**REF. NO. 167
FUEL LINES**

456 GT/GTA

RECALL CAMPAIGN NO. 167

INSTRUCTIONS FOR FUEL LINE REPLACEMENT

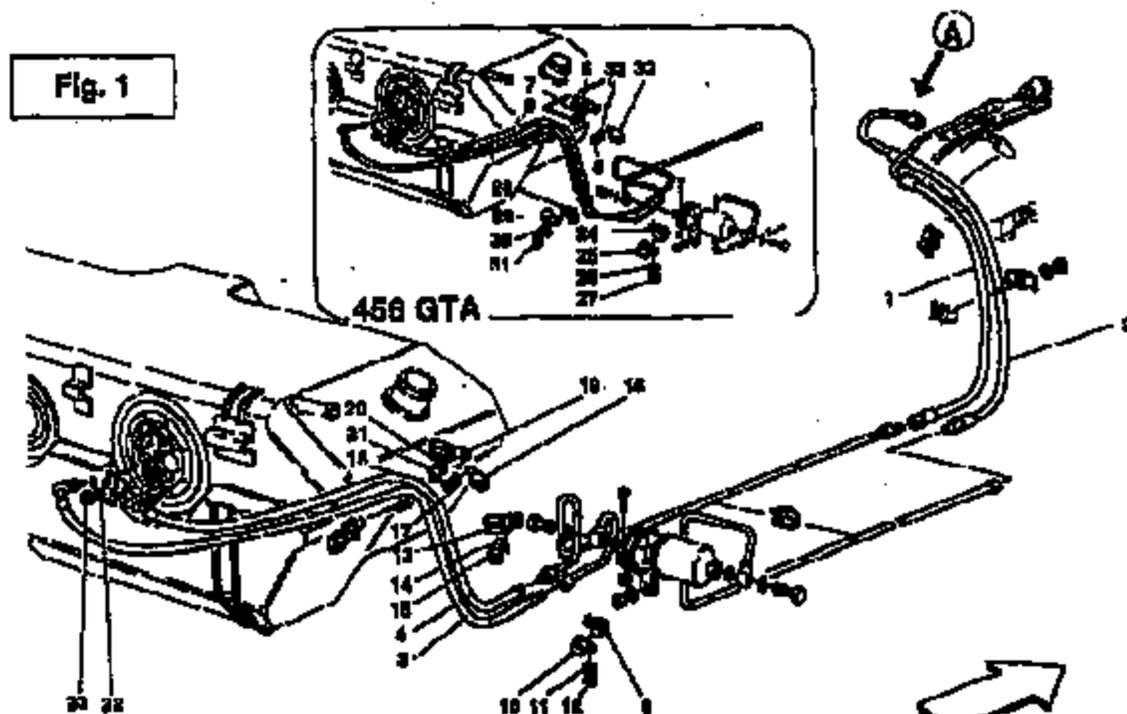
- 6) Remove the front wheels
- 7) Remove the rear section of the front inner fender panels
- 8) Loosen the inside of the left and right under tray covers
- 9) Release the supply and return hoses from their retaining clips on the right side.
- 10) Remove the cable ties on both the left and right sides.
- 11) Remove the water hose clamp on the right side to gain better access.
- 12) Remove both left and right fuel rail covers
- 13) Remove the left side fuel lines (Items 1 and 2 in figure 1)
- 14) Remove the right side fuel lines (Items 1 and 2 in figure 1)

- 15) Install the new right side supply (part number 178527) and right side return (part number 174046) fuel lines tightening the unions to a torque of 34 Nm.(25 lb.ft.)

- 16) Install the new left side supply (part number 178526) and left side return (part number 174051) fuel lines tightening the unions to a torque of 34 Nm.(25 lb.ft.)

FIGURE 2

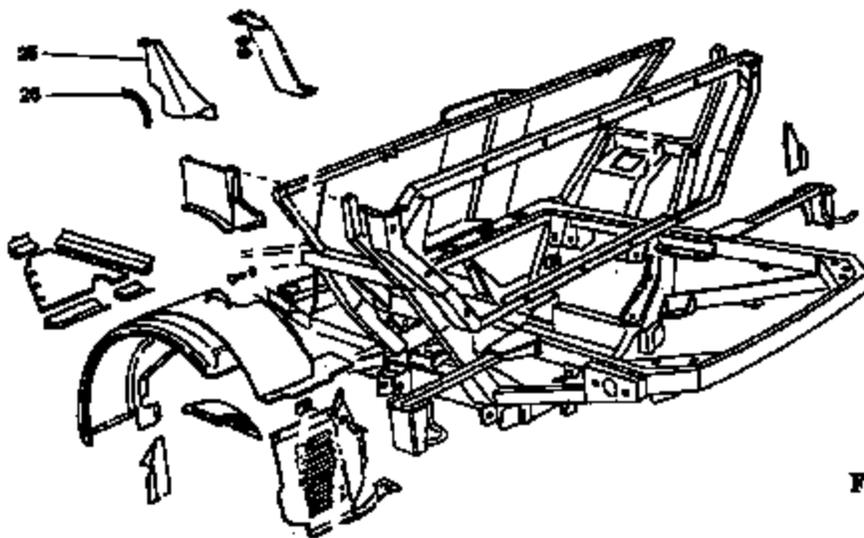
- 27) Remove both rear wheels.
- 28) Remove the sheet metal panel (#25 figure 2)
Ensure that the protective rubber strip (# 26 figure 2) stays in place.

- 29) Remove the delivery and return hose mounting brackets from both the left and right sides.
- 30) Loosen and remove the fuel line fittings at the fuel pump and remove the lines from the bracket.
- 31) Disconnect one fuel line from the rigid metal line on the left side and from the fuel pump and remove it from the vehicle.

- 32) Identify the new lines and separate left from right.
- 33) Route the new line in place of the one removed.
- 34) Connect the new line to the rigid metal pipe and torque to 34 Nm. (25 lbs. Ft.)
- 35) Note the position of the line at fuel pump and remove the other line from the fuel pump and rigid metal pipe.
- 36) Route the new line in place of the one removed.
- 37) Connect the new line to the rigid metal pipe and torque to 34 Nm. (25 lbs. Ft.)
- 38) Connect both lines to the fuel pump taking care not to damage the sealing rings.
- 39) Repeat the above steps on the right side to replace the lines.
- 40) Please mark all updated vehicles with a dot of re paint on the fuel line 178527 upper fitting.
